**DRAFT FINAL**  
**Third Five-Year Review Report**  
**for**  
**Sacramento Army Depot**  
**Sacramento**  
**Sacramento County, California**

**August 2007**

**Army Response to EPA Comments on the Draft Third Five-Year Review Report for  
Sacramento Army Depot, Sacramento California, June 2007**

CURRENT FACILITY MAP

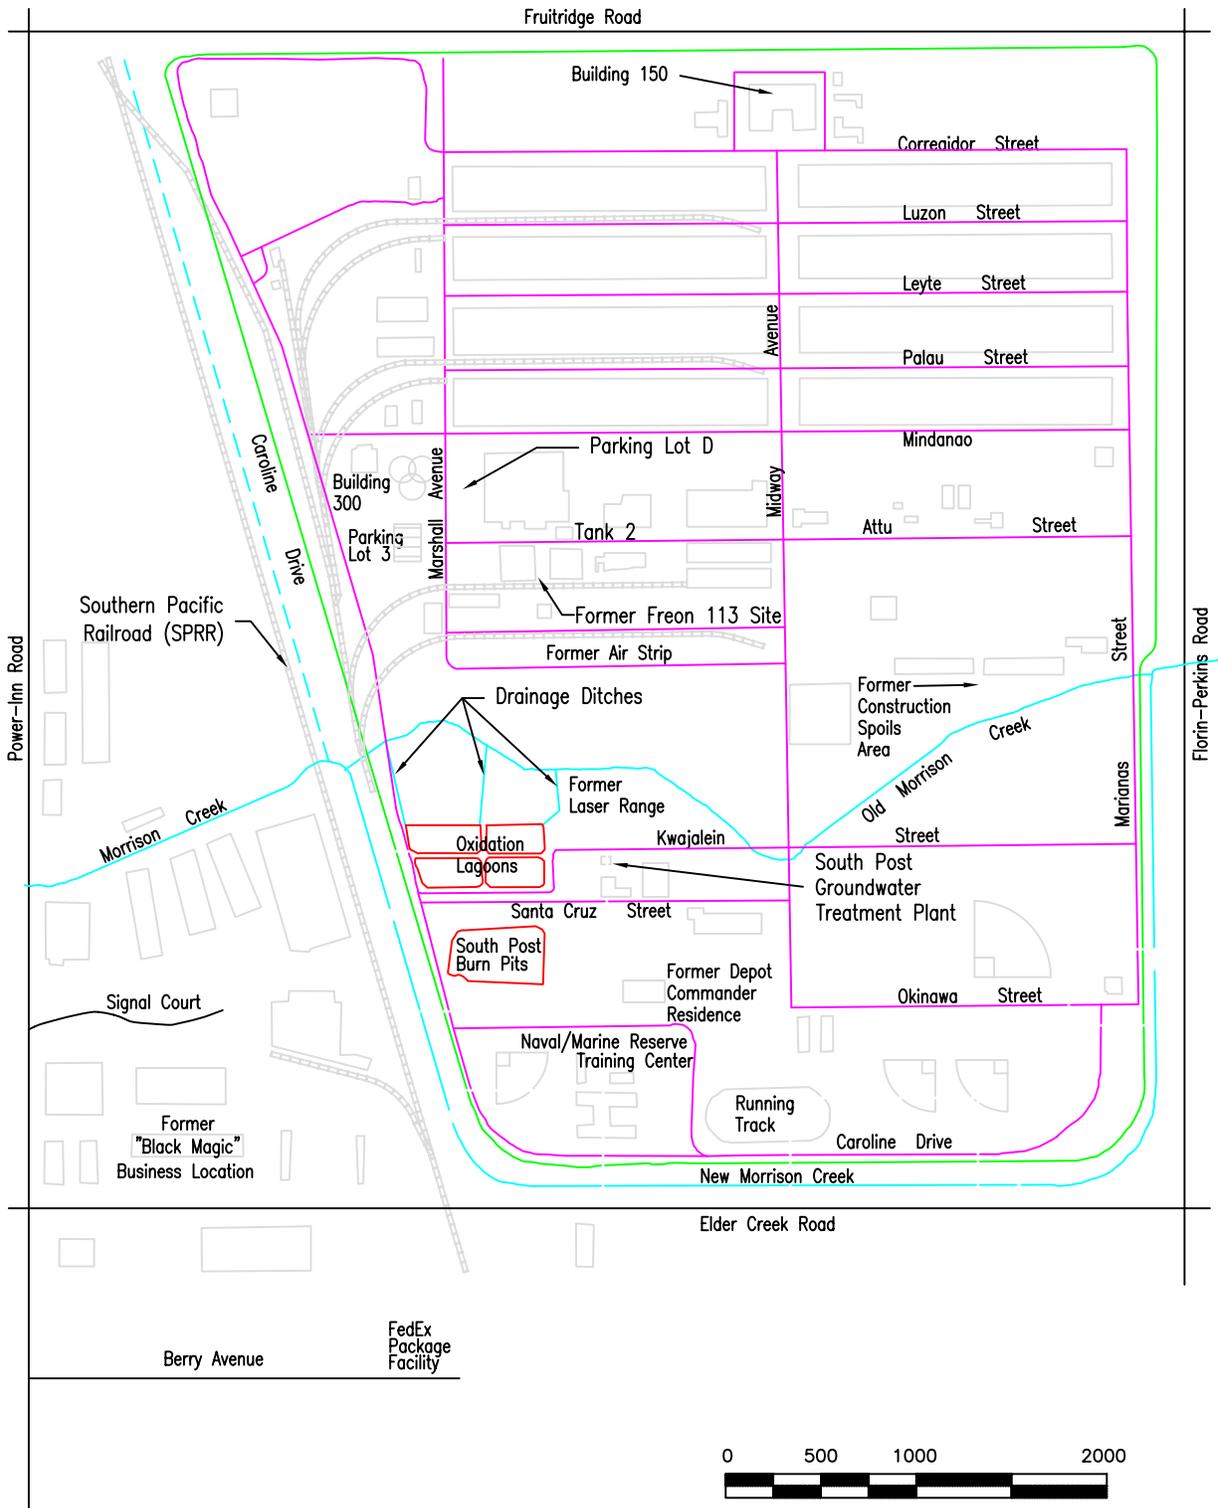
3. **Plate 2, Current Facility Map, Sacramento Army Depot:** It is not clear if Plate 2 has been updated since the drawing date is listed as “09-12-05;” if correct, this date indicates that the plate may not include more current information such as the transfer of Parcel 2B to the City of Sacramento, which (per Table 1) occurred in April 2006, after the date of the drawing. Please review Plate 2 and where appropriate revise the dates and/or information to reflect the current (i.e., late 2006 or early 2007) status of the information, as well as the noted drawing date.
